PLANNING COMMISSION MEETING TUESDAY, JULY 12, 2022 6:00 P.M. Council Chambers 40 W MAIN ST, NEWARK, OH 43055

5. SITE PLAN REVIEW FOR 1000 BRICE ST. - NEW COMMERCIAL BLDG. FOR PRIVATE GYM-RECREATION

JULY 12, 2022 PLANNING COMMISSION MEETING

1. PC FILE 2022-24: SITE PLAN FOR NEW COMMERCIAL BUILDING FOR PRIVATE GYM-RECREATION, 1000 BRICE STREET

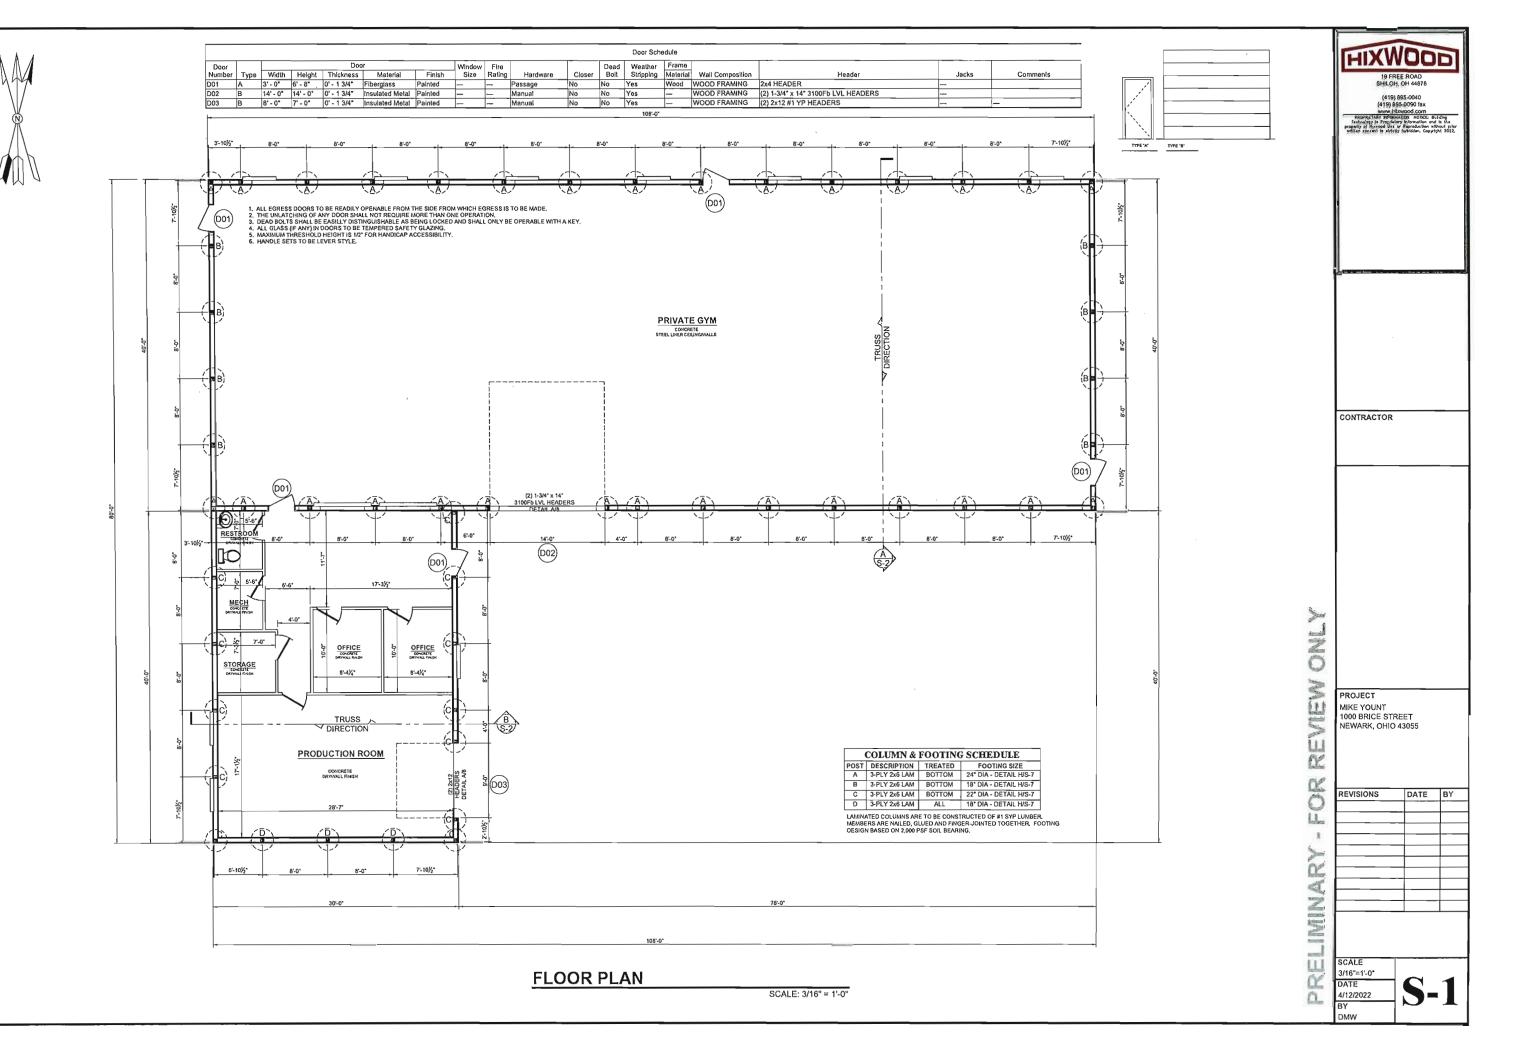
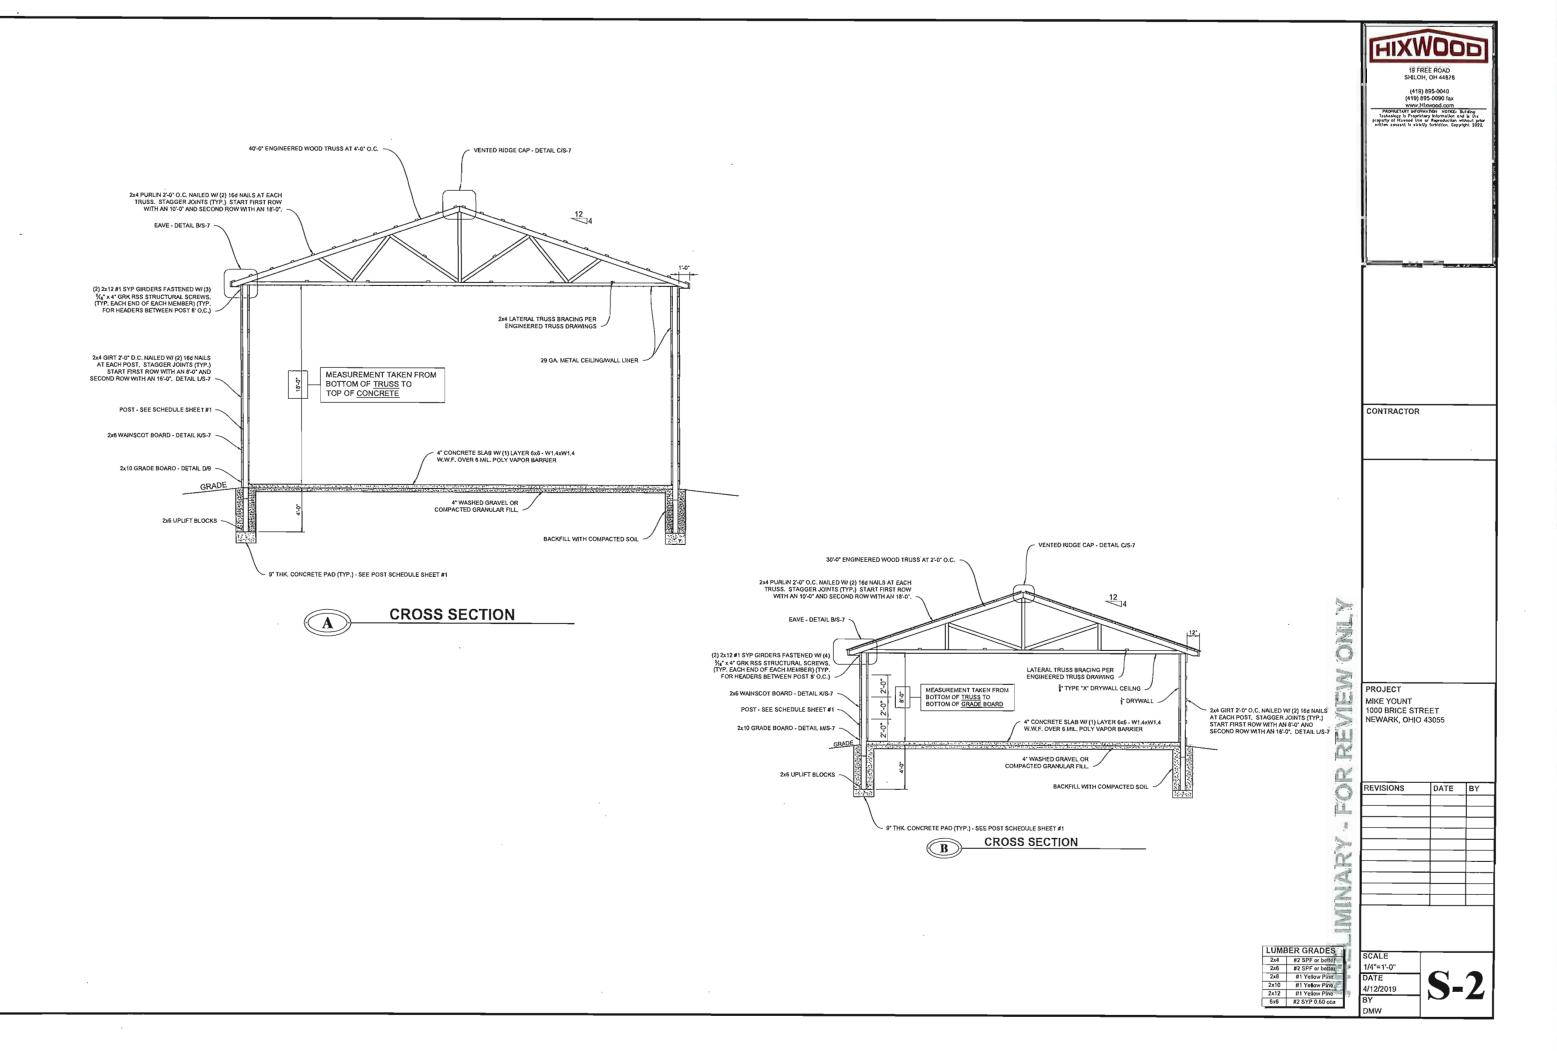
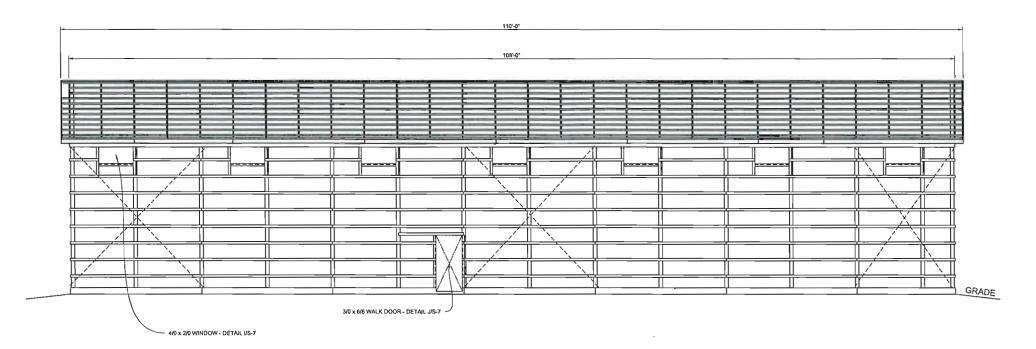
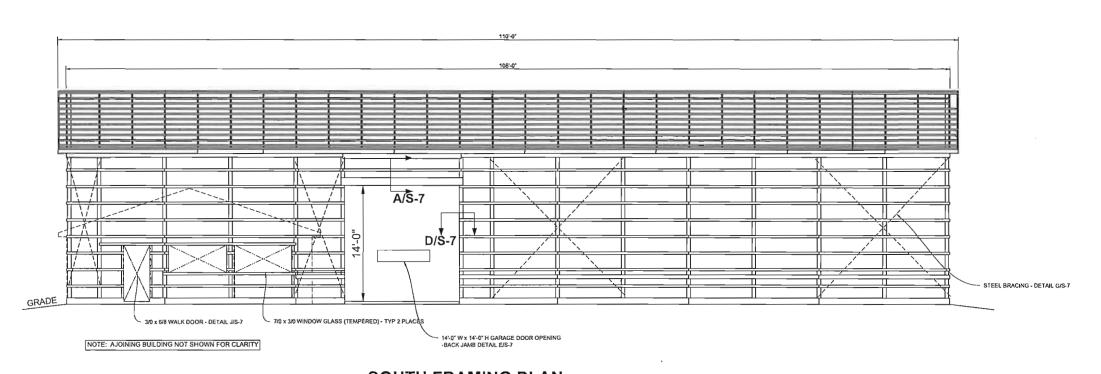
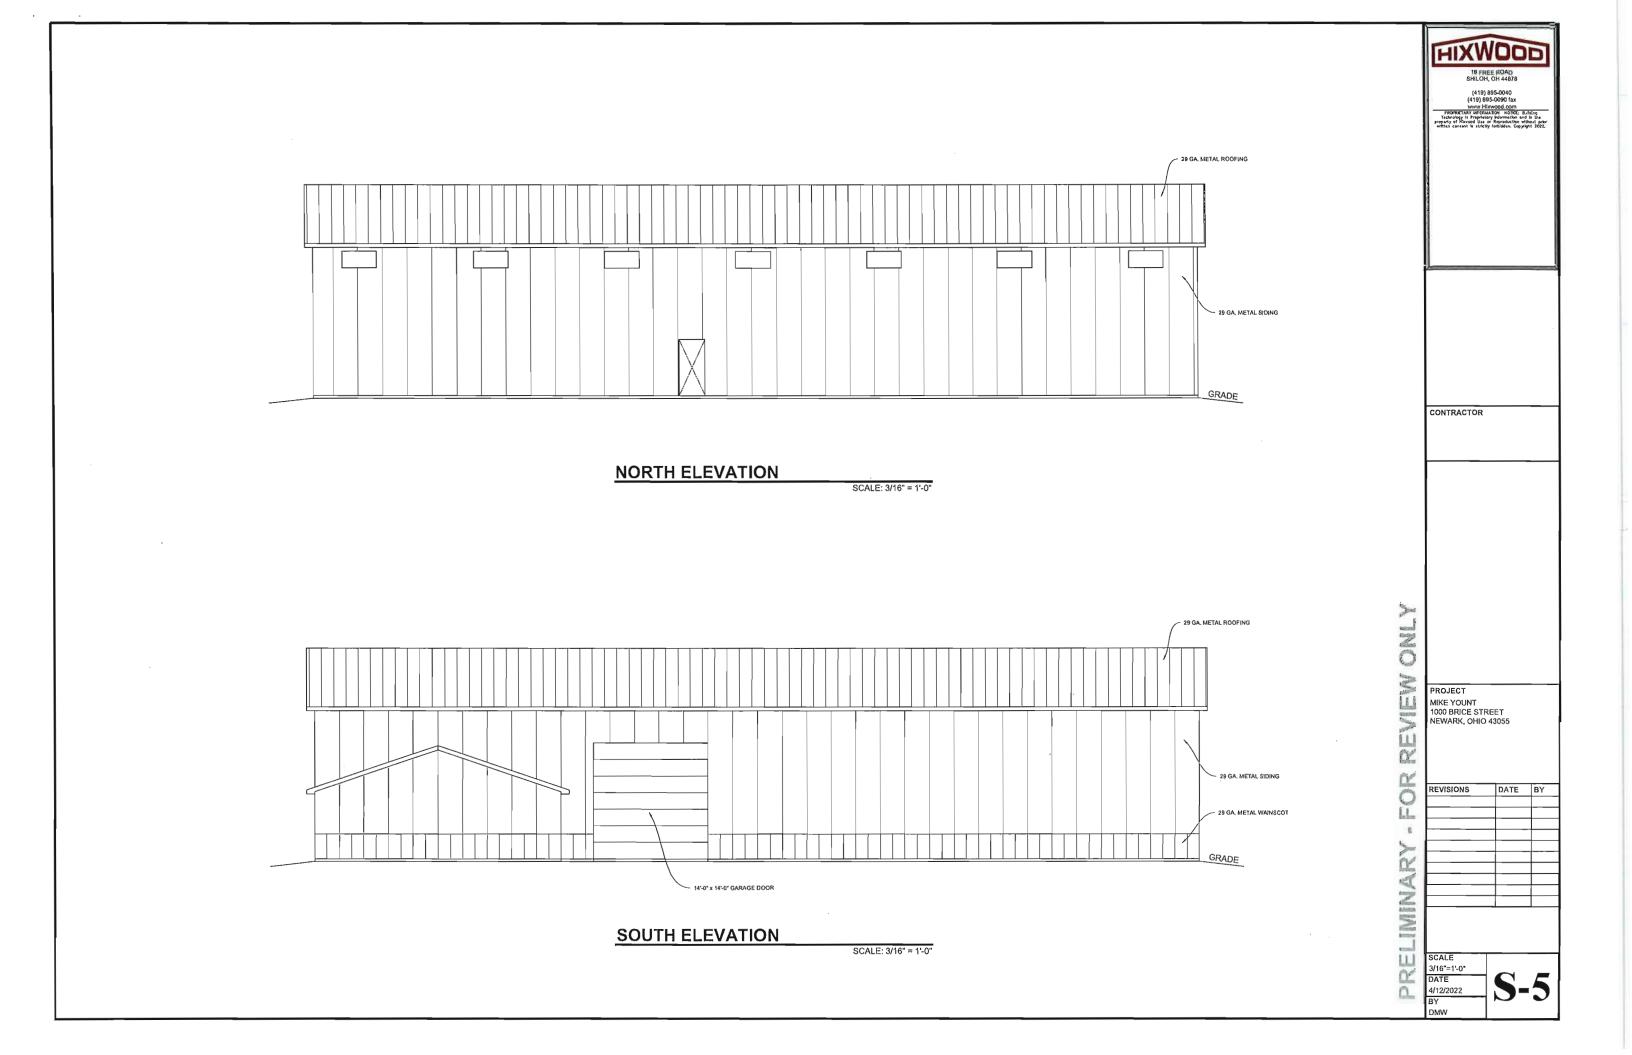
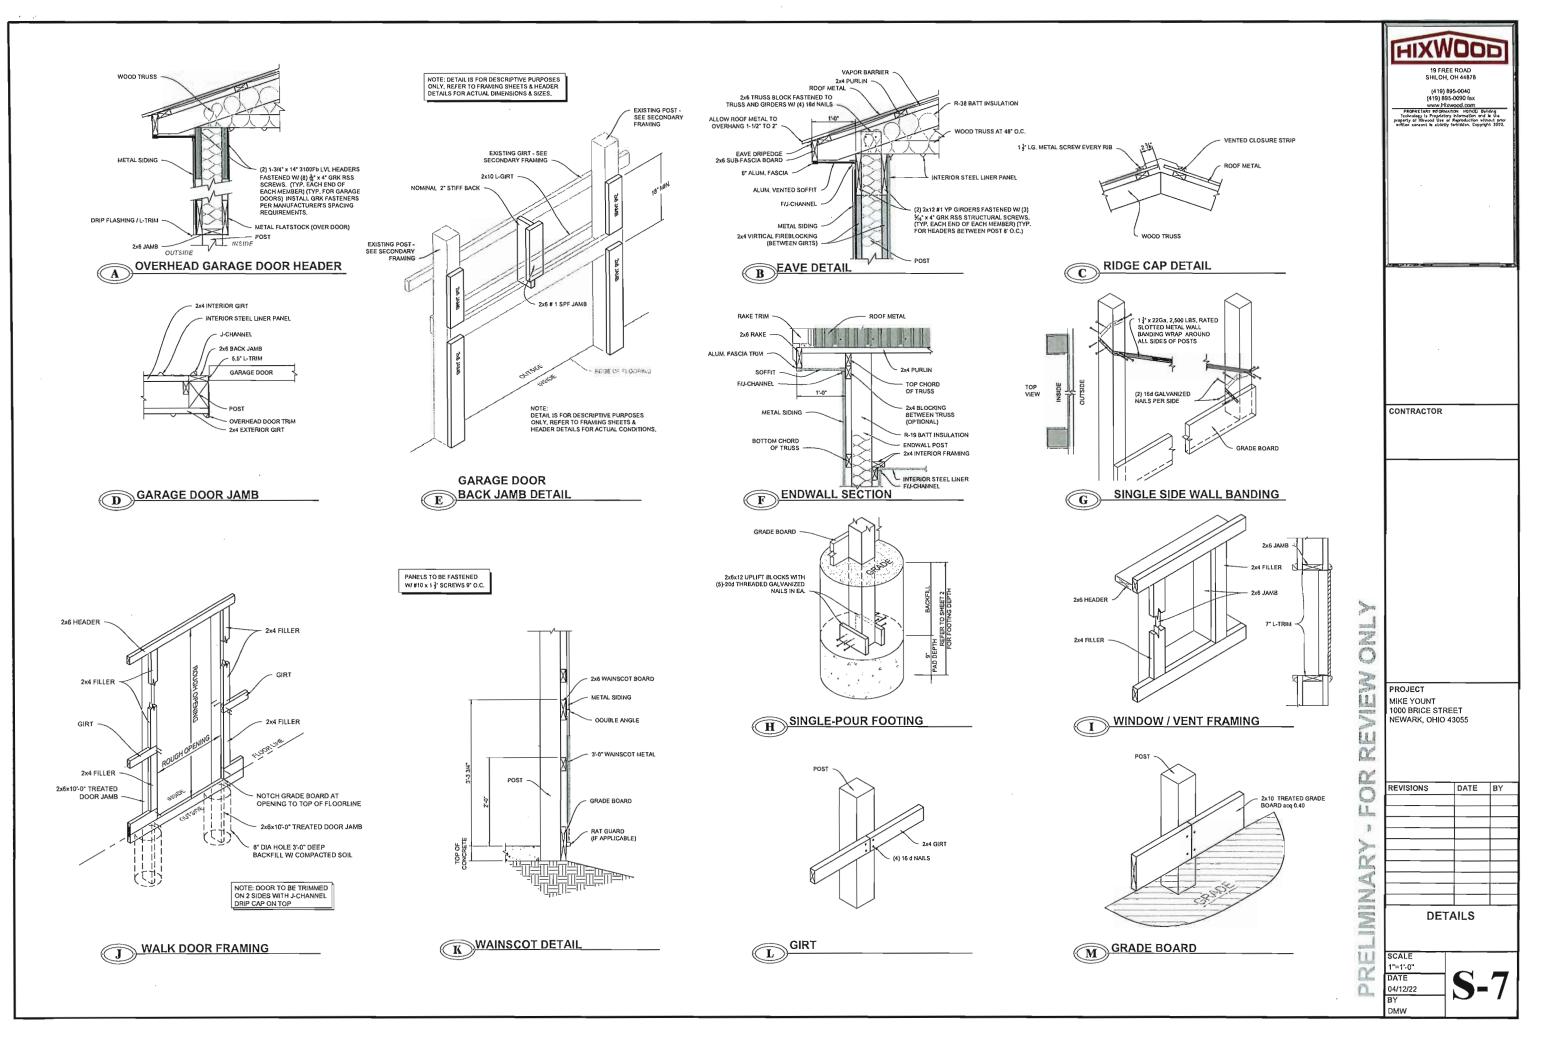
The Fire Division stated that "Proper Fire Department Access needs to be provided since the furthest point of the building is beyond 150' from the road. Separation distances of buildings on the same lot could be a problem depending on the construction types and distances in the Ohio Building Code. The required distance would be a Building Code question." The designer should review those requirements before construction plan submittals.

The building designer shall contact Bruce Gossett, Newark Fire Dept., to arrange a meeting to discuss the issues related to the OFC.

Code requires 5 parking spaces for the new development on this site, and no new spaces are specifically proposed. Recognizing the current use for the proposed building as a private gym, a plan shall be submitted to delineate 5 future parking spaces, as a future use would require this area.

No new utilities are shown for this structure, however there is a restroom facility shown on the plans. A plan shall be submitted for approval detailing the water and sanitary sewer facilities required for this construction.

There has been no stormwater management plan submitted, and this should be submitted and reviewed prior to zoning approval, to ensure no adverse impacts to the adjacent properties.

Staff recommends approval of this site plan at this time, <u>contingent upon the</u> resolution of the issues listed:

- 1. Fire Dept comment regarding OBC, OFC sections listed are addressed.
- 2. Water and Sanitary Sewer service plans are submitted and approved.
- 3. Future parking space plan submitted and approved.
- 4. Stormwater construction plans are submitted and approved. Compliance with

City's Stormwater Management requirements, to ensure runoff water does not adversely impact adjacent properties.

5. Any of the remaining issues listed above will be addressed on the final construction plans.
